PIVOT ARCHITECTURE

ADDENDUM # 5

Project: **Klamath Community College Childcare Learning Center (2331.00)**

Date: September 4, 2025

1 S211 ROOF FRAMING PLAN - SECTOR A
1/8" = 1'-0"

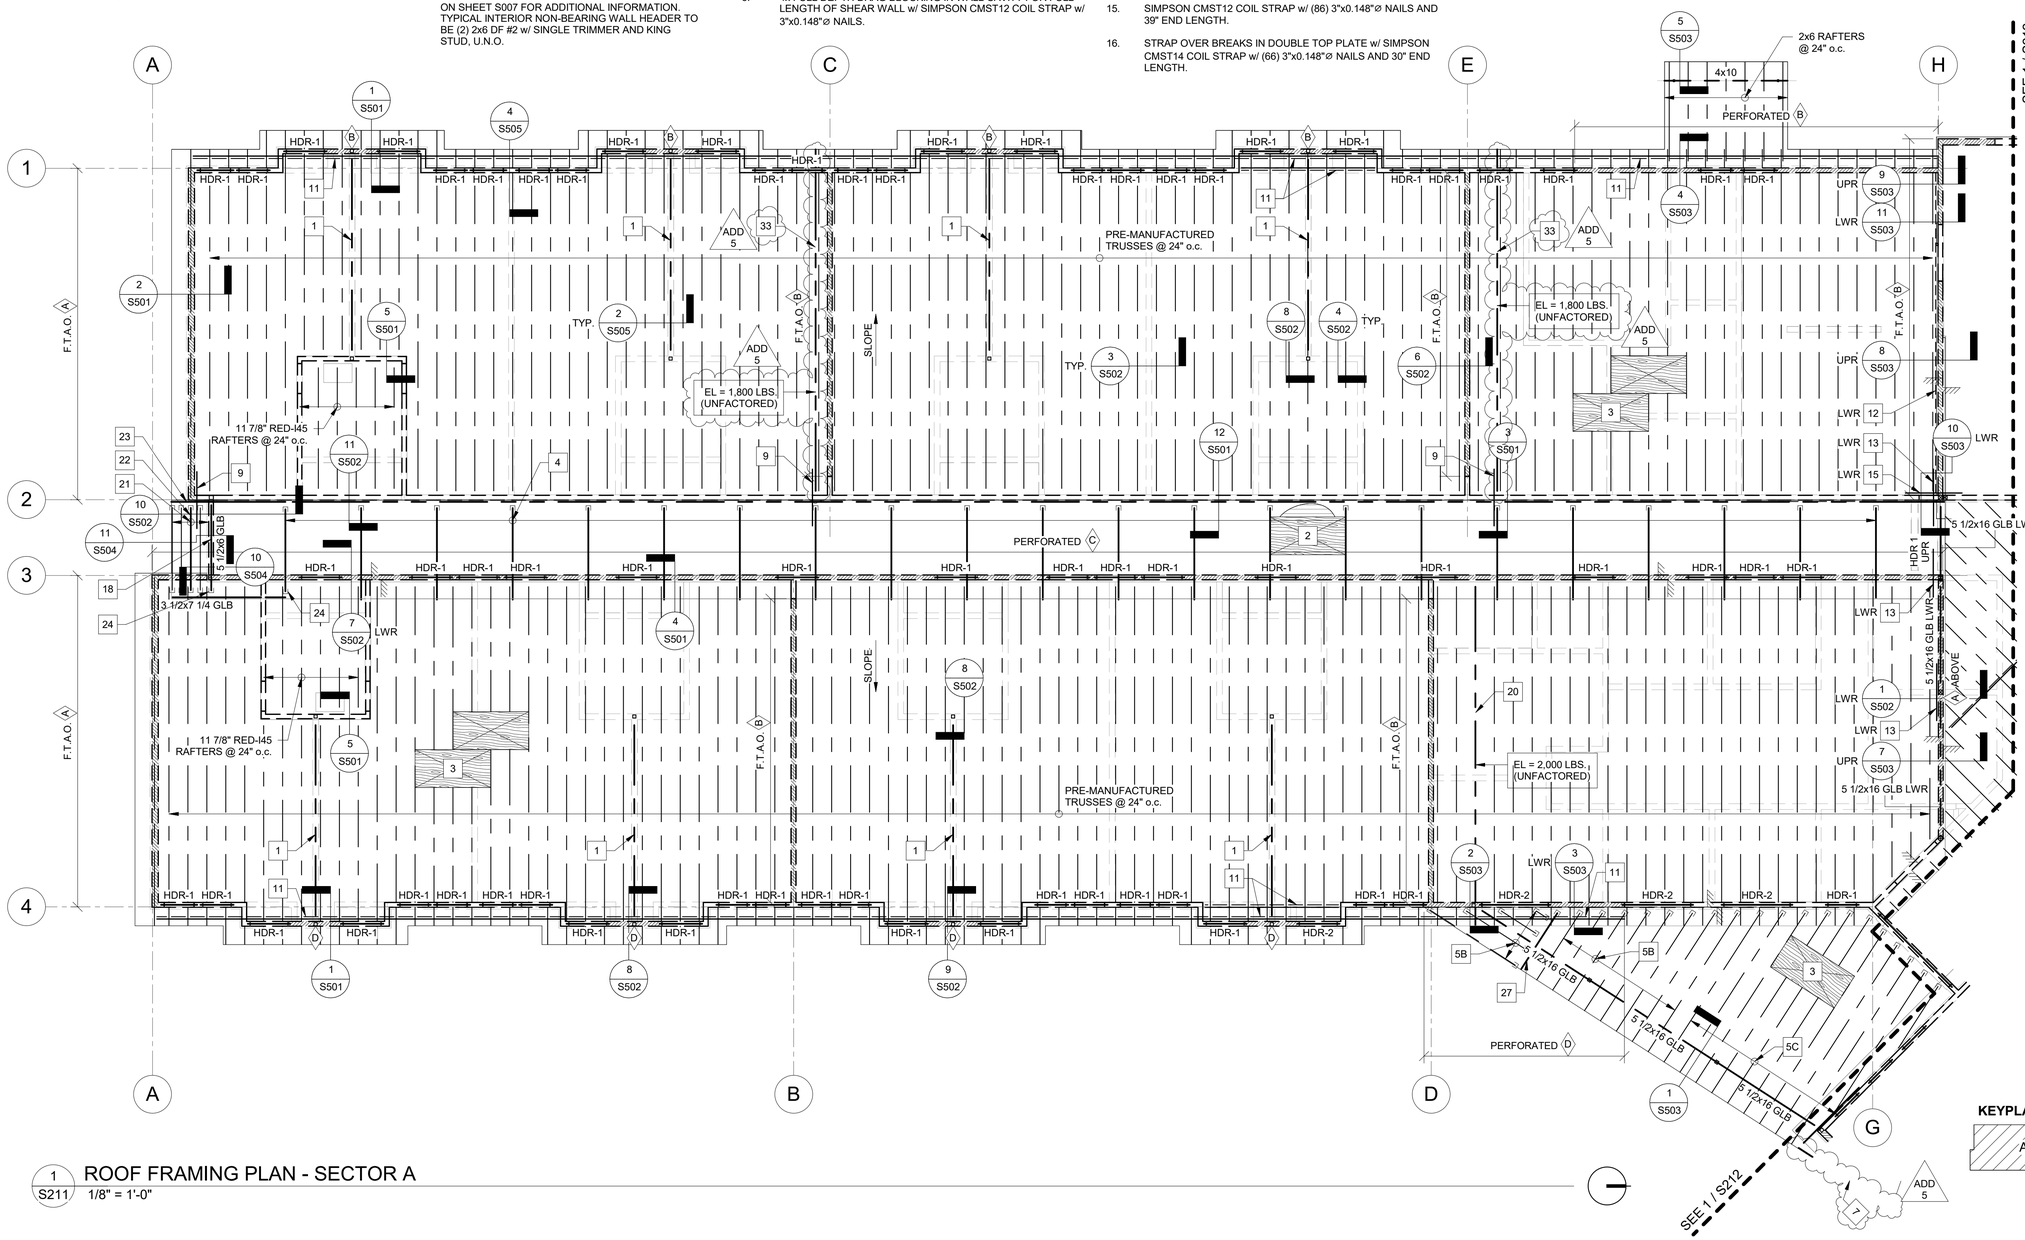
3.49. S211 ROOF FRAMING PLAN – SECTOR A

a. Hanger Revised to HWP612 in detail 7/S505

3.49.2. Added truss at two locations, see keynote 33.

3.49.3. Revised axial loading criteria for truss MFG

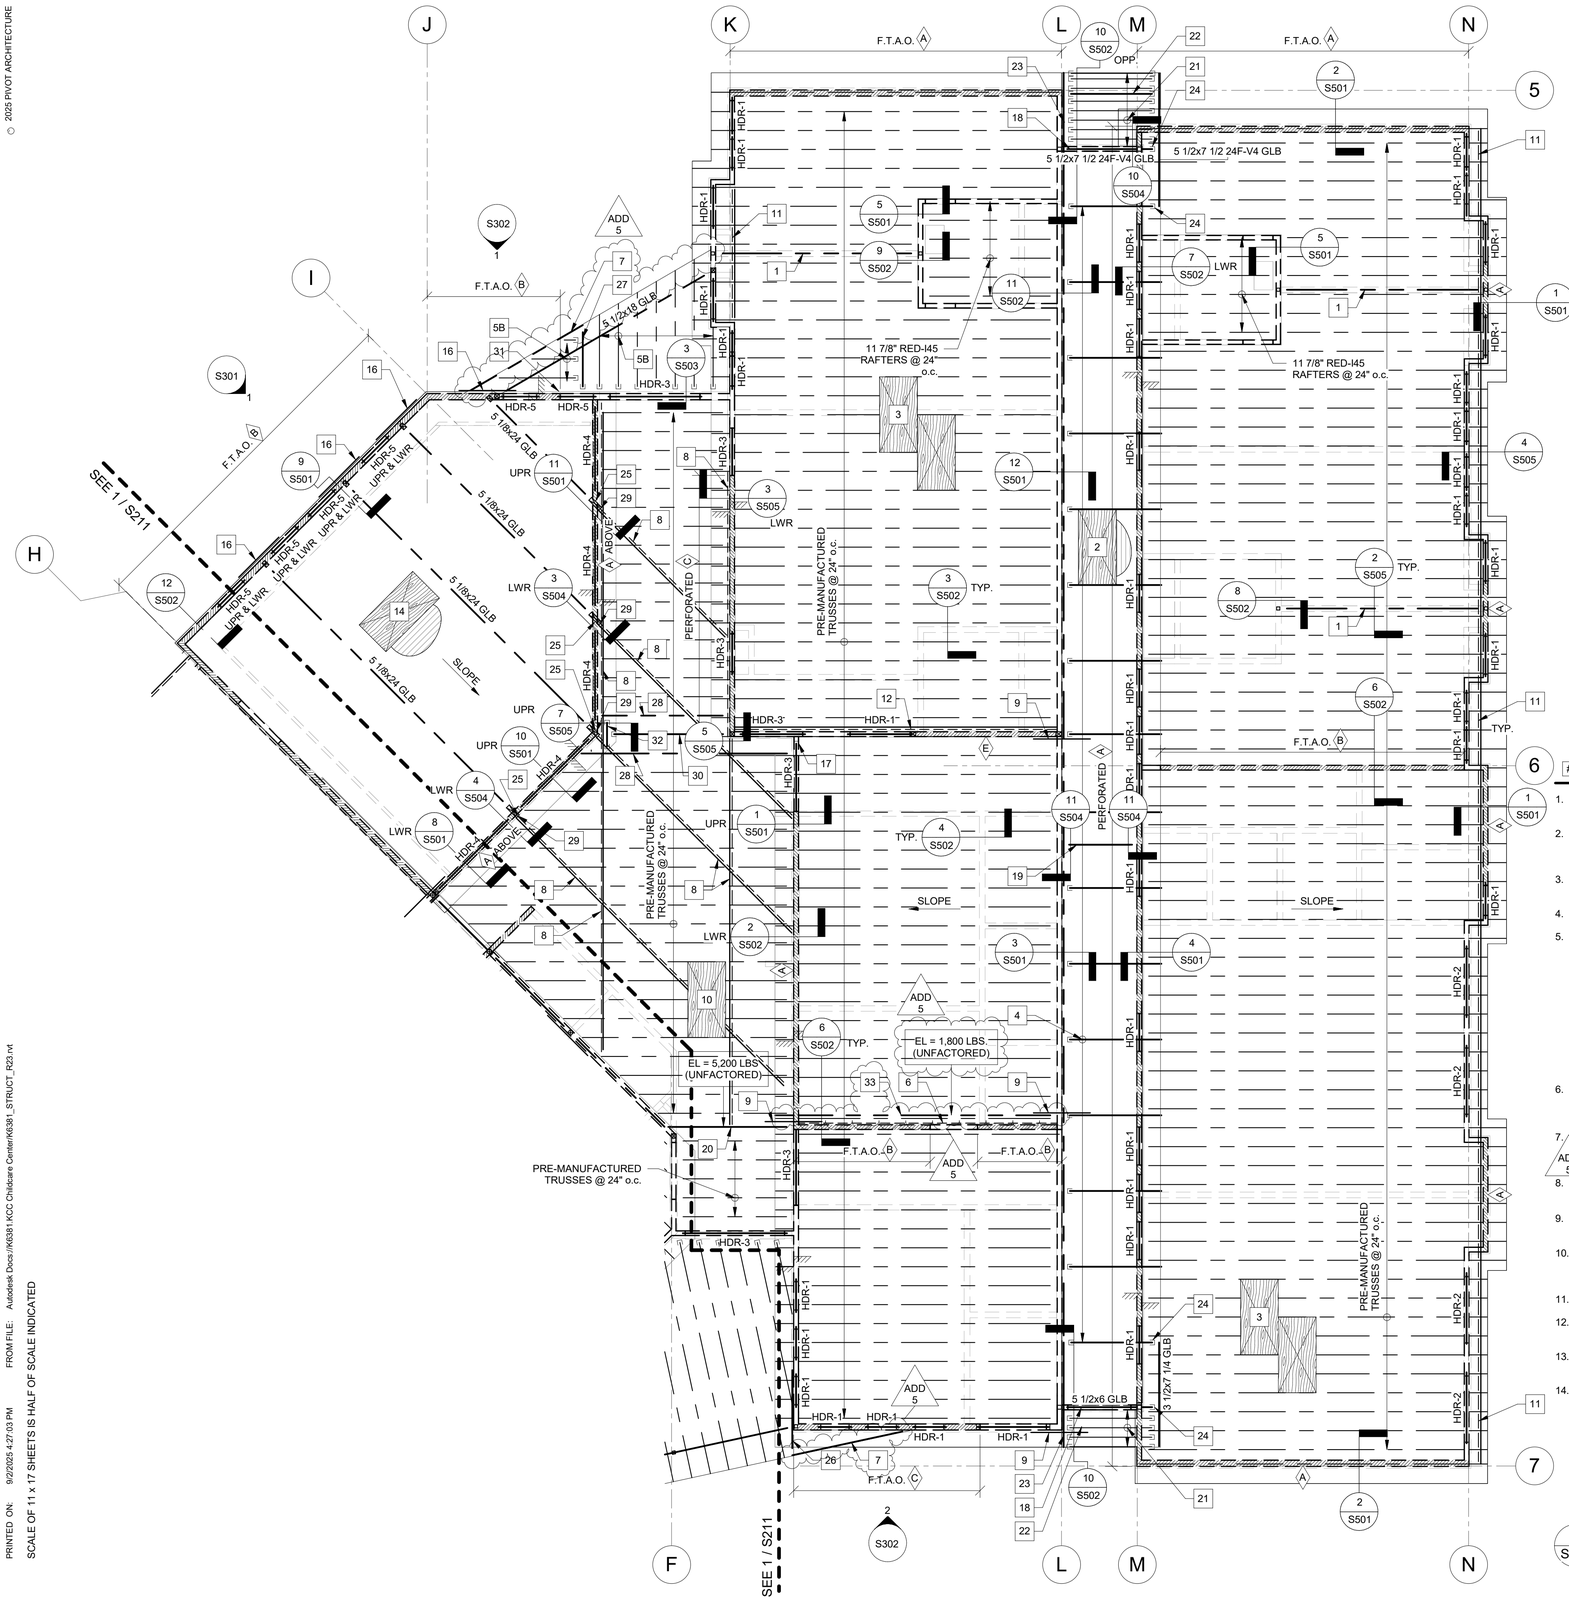
3.50. S212 ROOF FRAMING PLAN – SECTOR B

a. Hanger Revised to HWP612 in detail 7/S505

3.50.2. Revised Roof line at North Canopy to follow GLB angle.

3.50.3. Added structural fascia at ends of both entrance canopies.

a. Revised keynote 7 to define LVL structural fascia.

3.50.4. Added truss at one location, see keynote 33

a. Revised axial loading criteria for truss MFG

1 S213 HALLWAY WALL FRAMING PLAN - SECTOR A
1/8" = 1'-0"

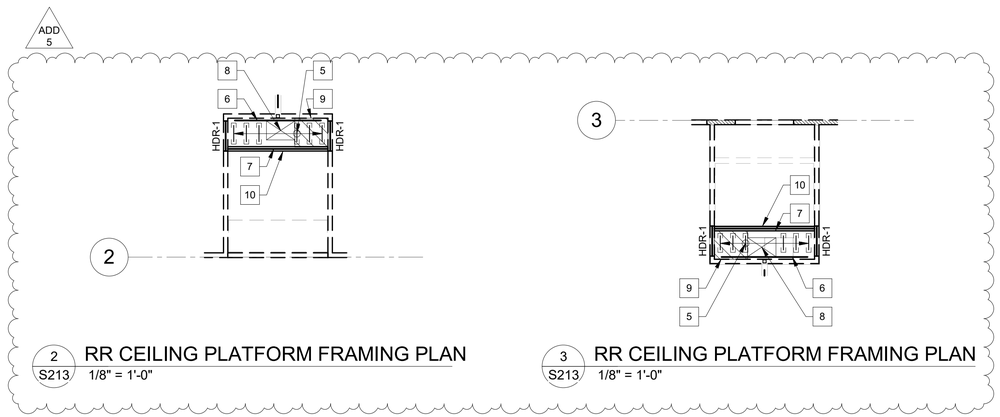
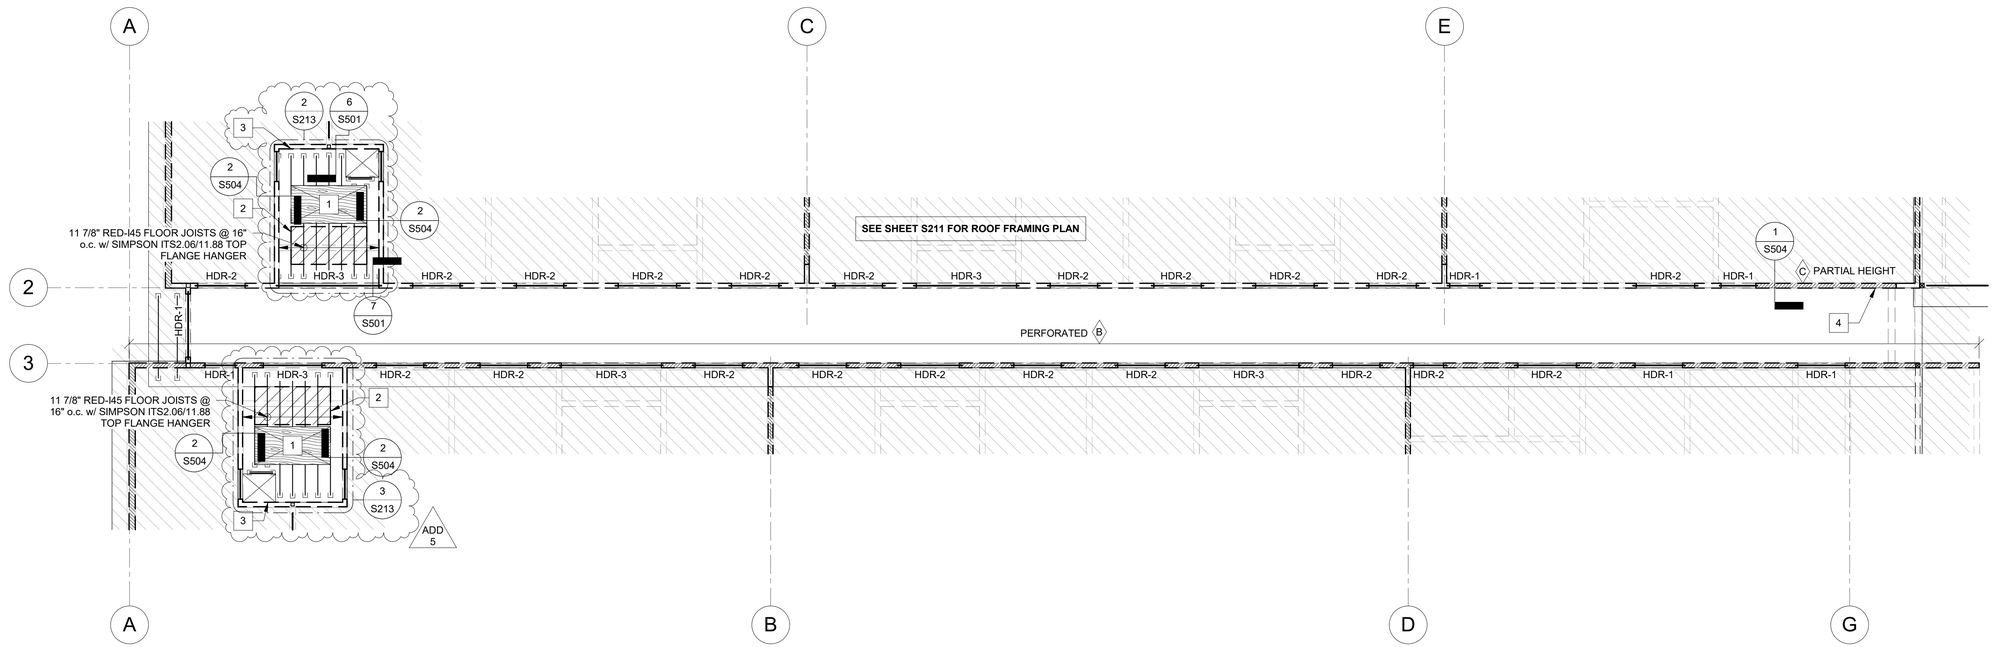
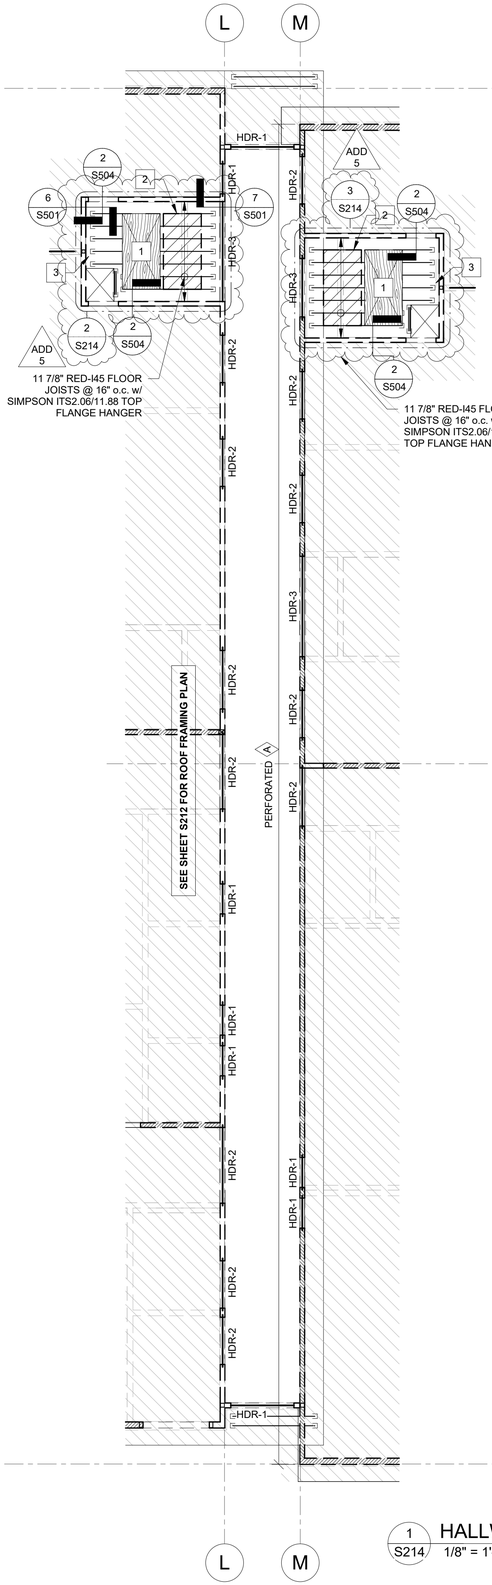
3.51. S213 & S214 HALLWAY WALL FRAMING PLAN – SECTOR A & SECTOR B

3.51.1. Added ceiling platform framing plans for access to mechanical mezzanines above.

3.51.2. Revised keynote 3 for new mechanical access opening size

3.51.3. Added keynote 5, 6, 7, 8, 9, 10 for framing requirements for ceiling platform.

3.51.4. Added Header-1 in restroom door openings

1 S601 SECTION THROUGH TUNNEL AT TREE
3/8" = 1'-0"

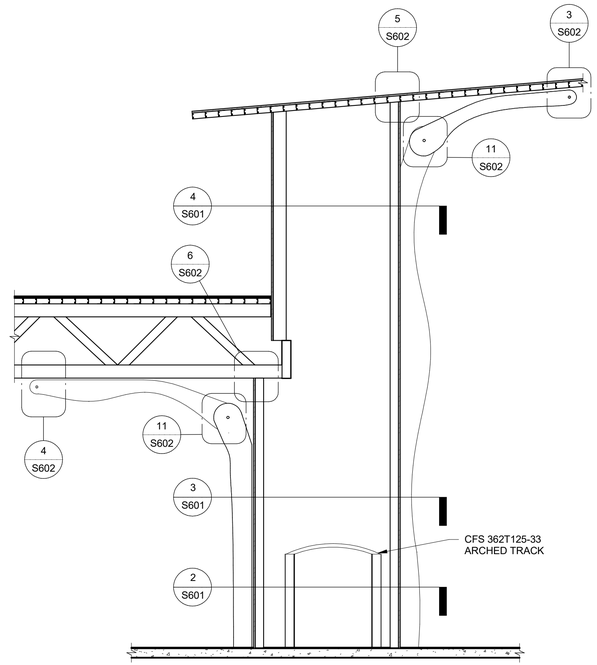
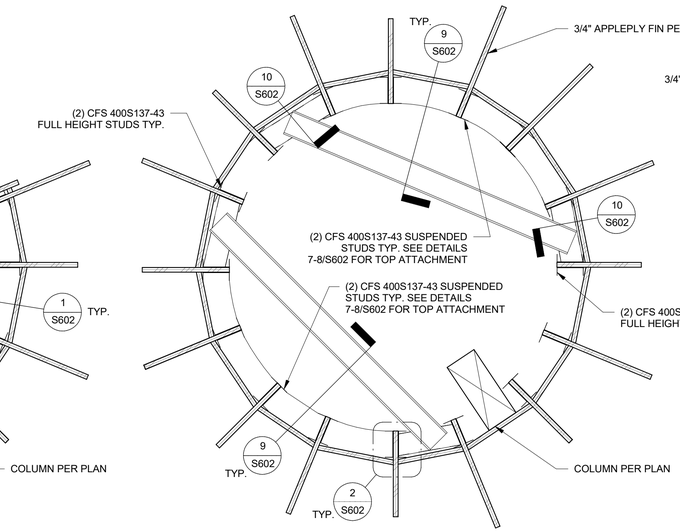
3.55. S601 COMMONS TREE – PLANS AND SECTION

3.55.1. Added Sheet

1 M301 1/16" = 1'-0"

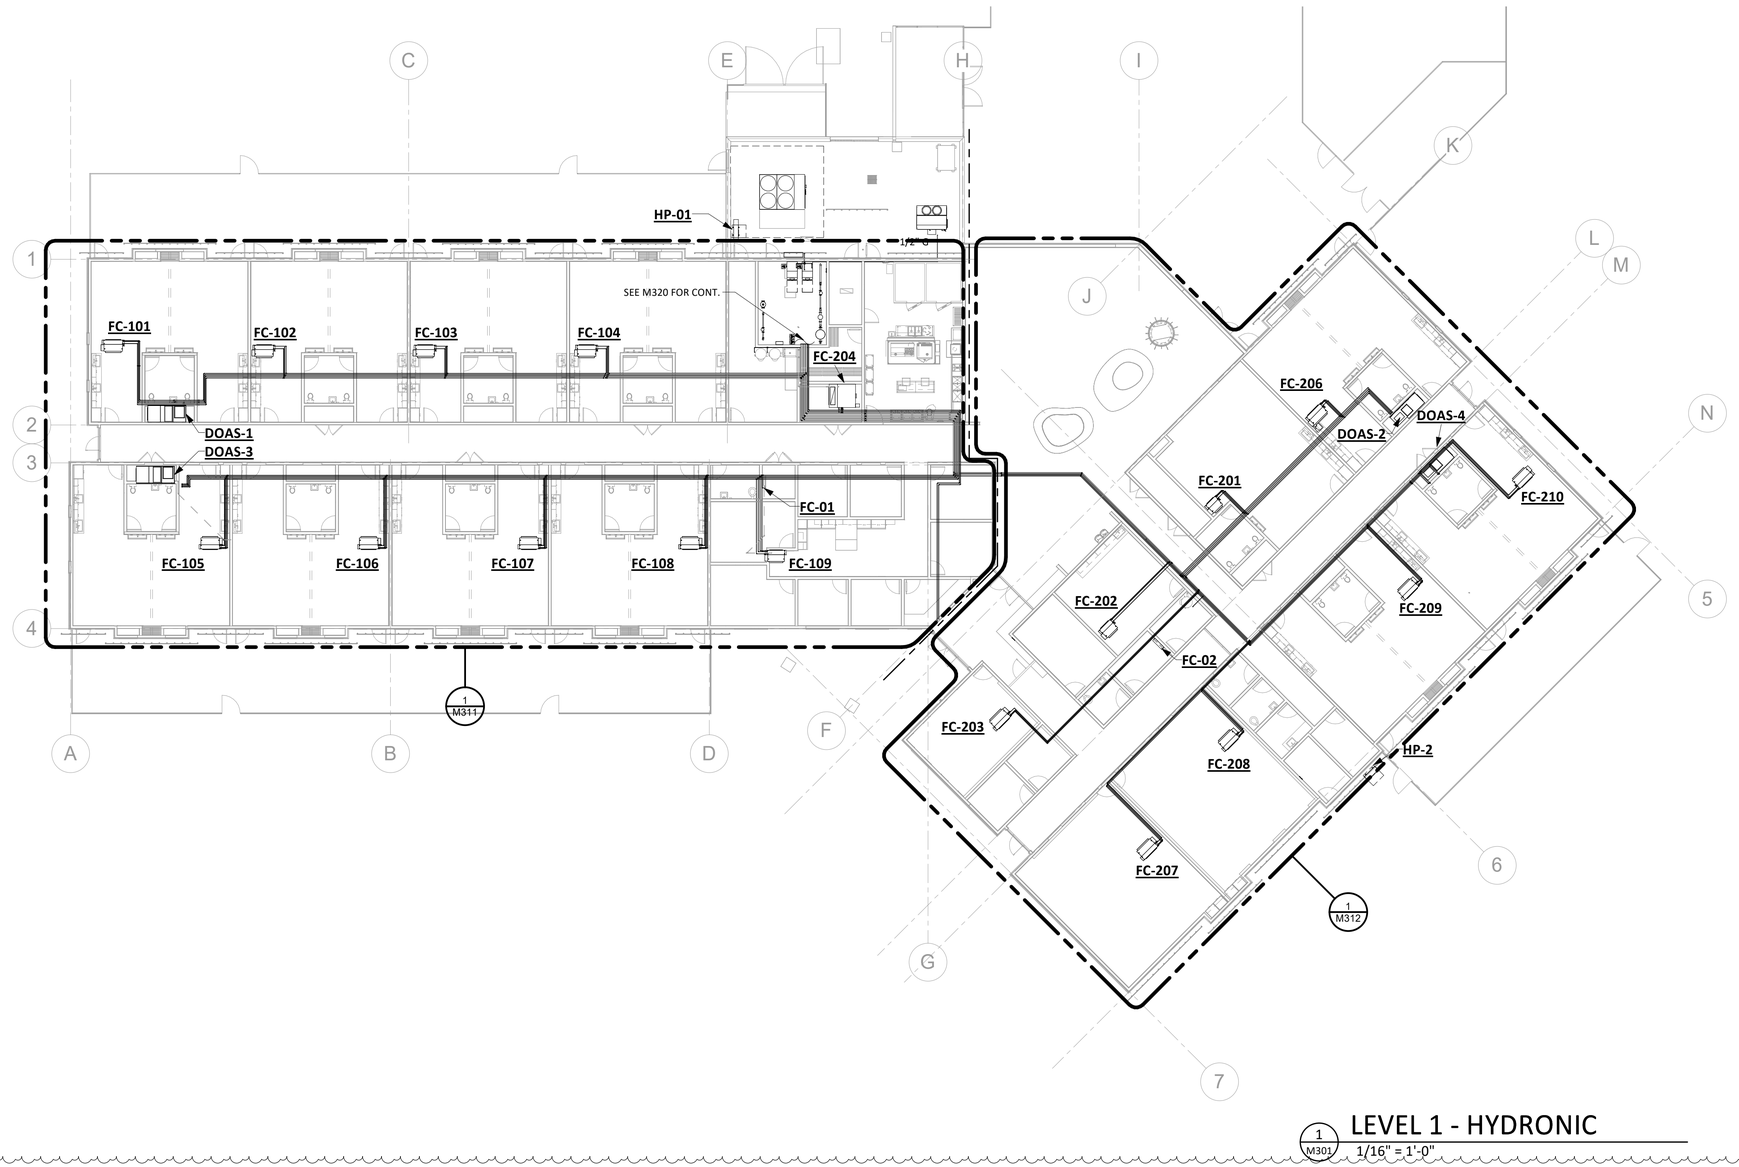
3.58. SHEET M301

3.58.1. – Plan updated with new hydronic pipe routing and added enlarged view tags
